Forsyth County Procurement

ADDENDUM #6

RFP 20-78-1620

For: Providing all labor, equipment and materials for the construction of a new Juvenile Justice Center at 875 Lanier 400 Parkway, Cumming, GA 30040. Project includes a multi-phased site development, demolition of existing motel structures and construction of new 62,000 square foot Juvenile Court building.

Sheet No.
E-0.02
RELEASED FOR CONSTRUCTION

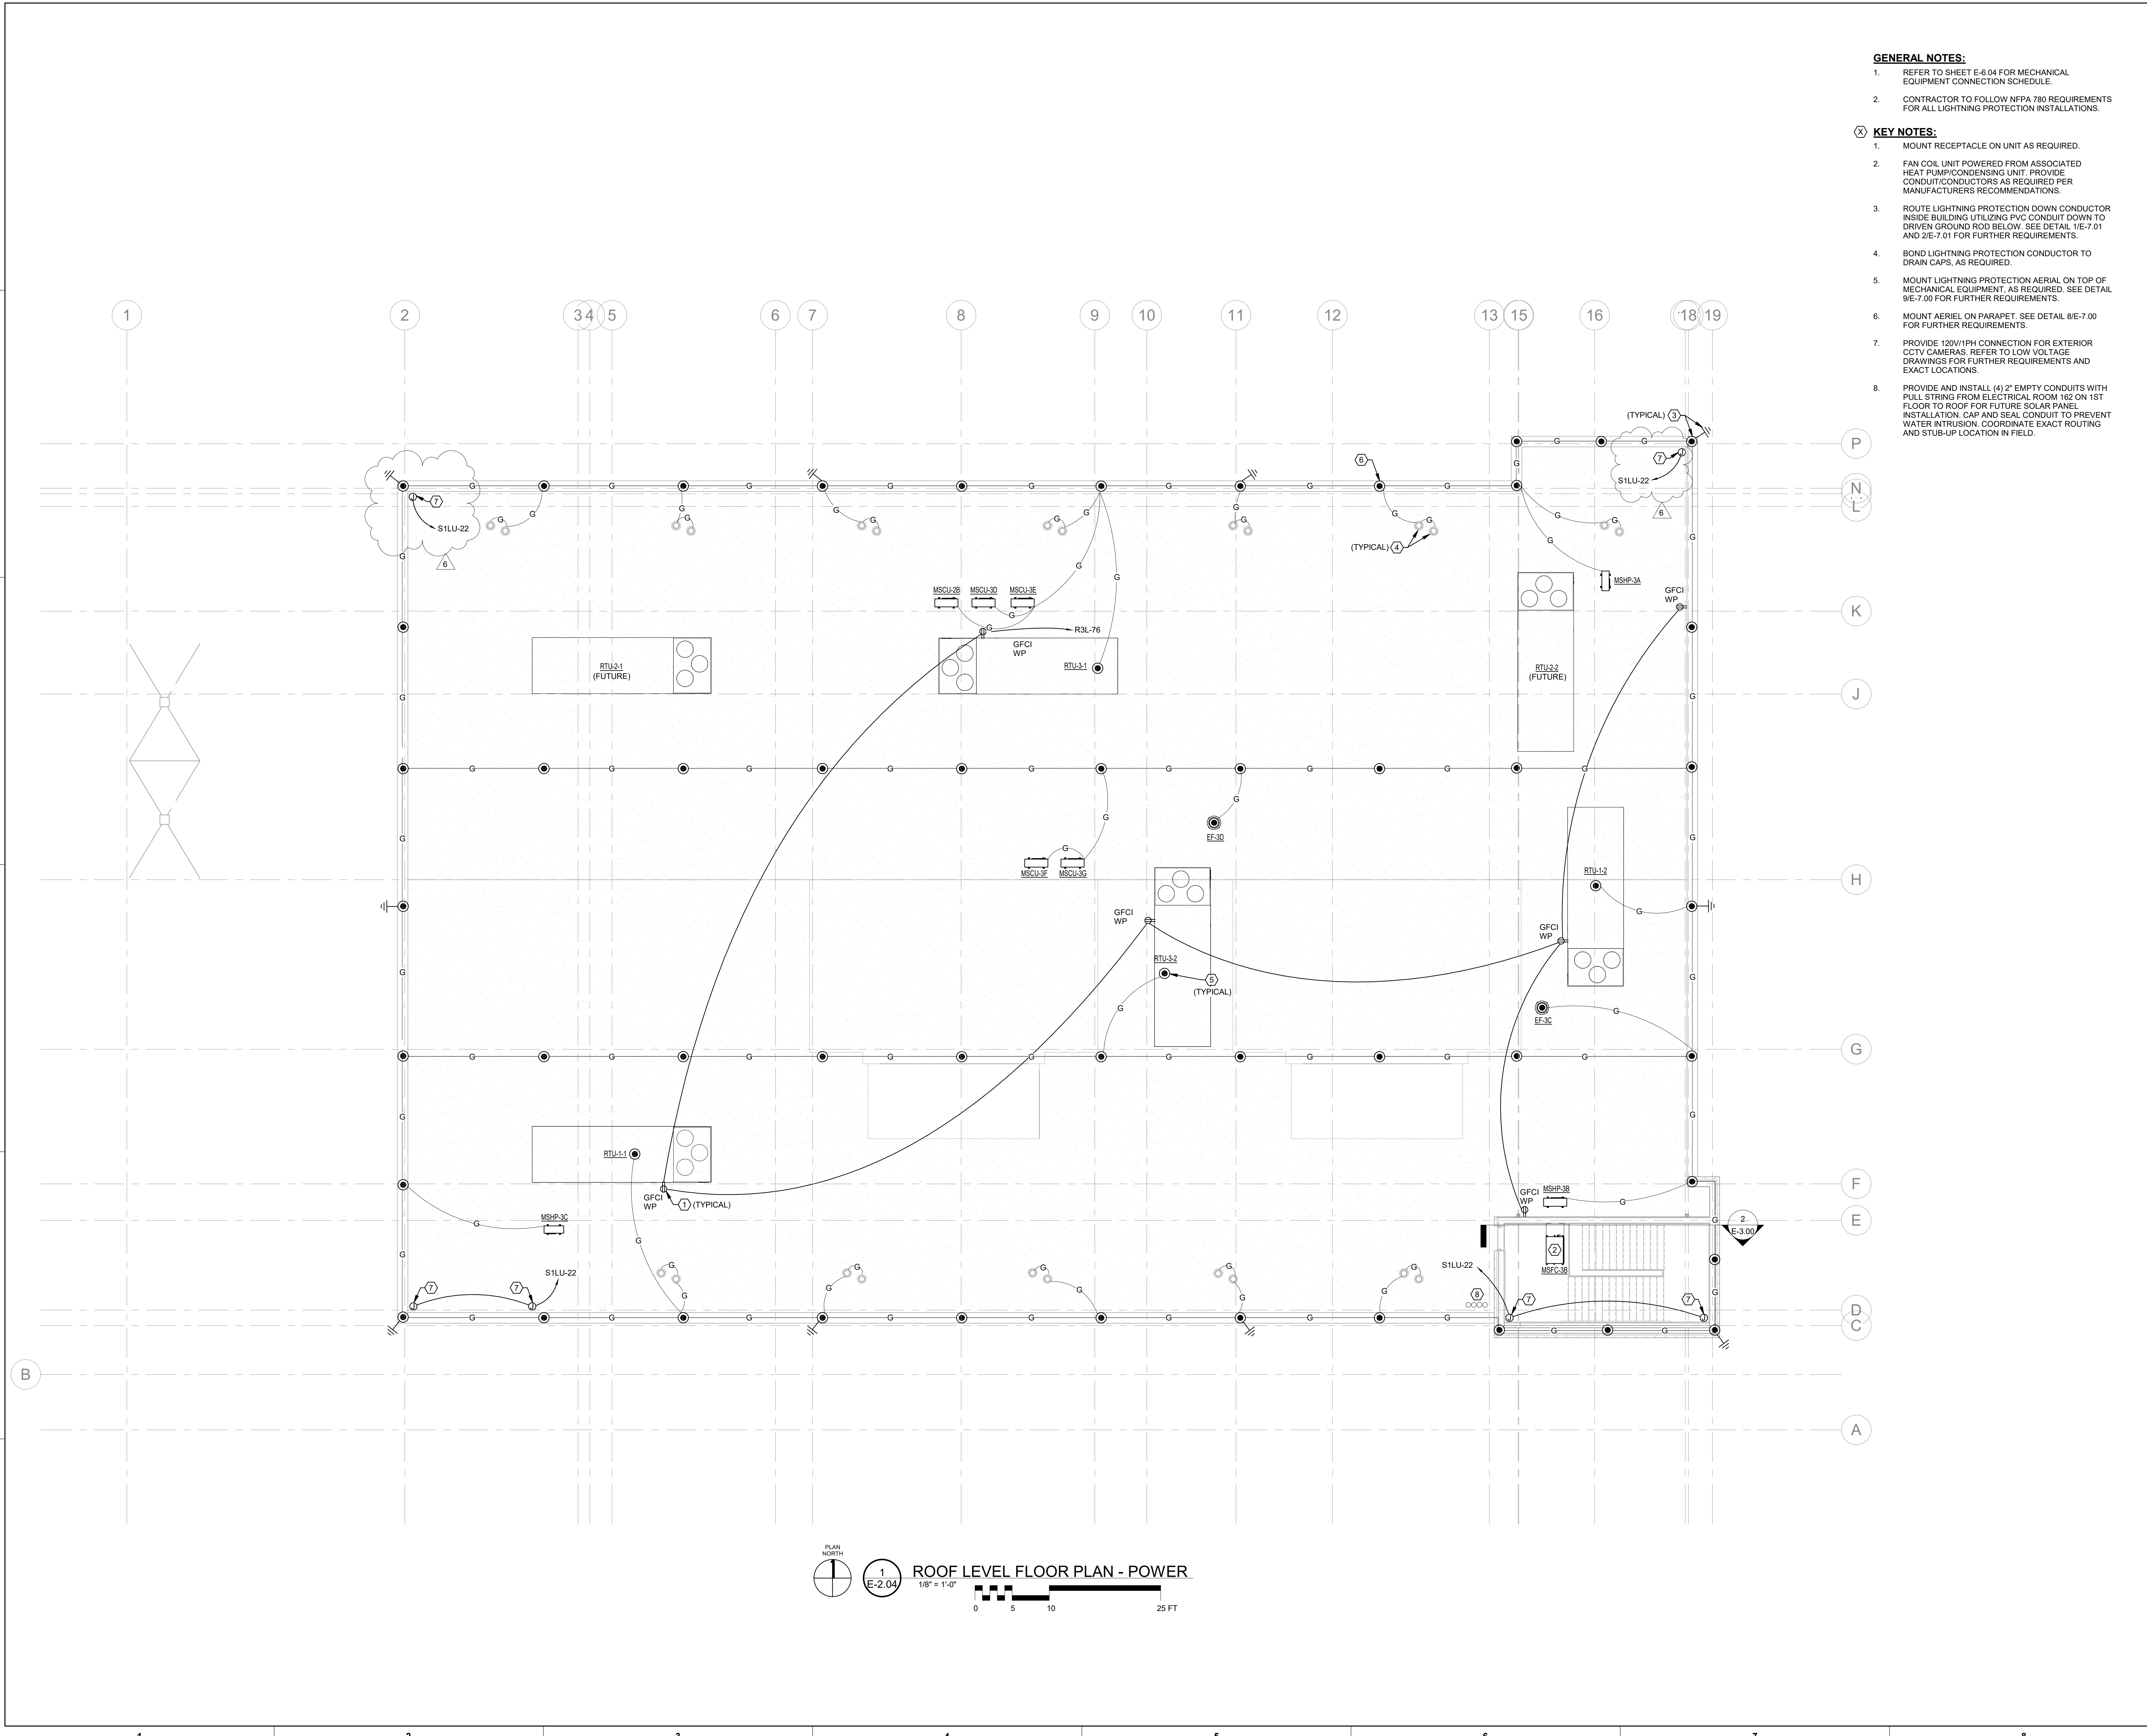
1. Added Sequence of Operation for Georgia Power Shutdown and Switchover.
2. Reference sheet E-0.02 ELECTRICAL SITE PLAN – PHASE ONE revised under addendum #06 dated 07/16/2020.

- i. RESPONSE: **Georgia Power to coordinate temporary power routing, phasing and shutdown with Forsyth Co. refer to drawings E-0.02, E-0.03 and E-0.04**
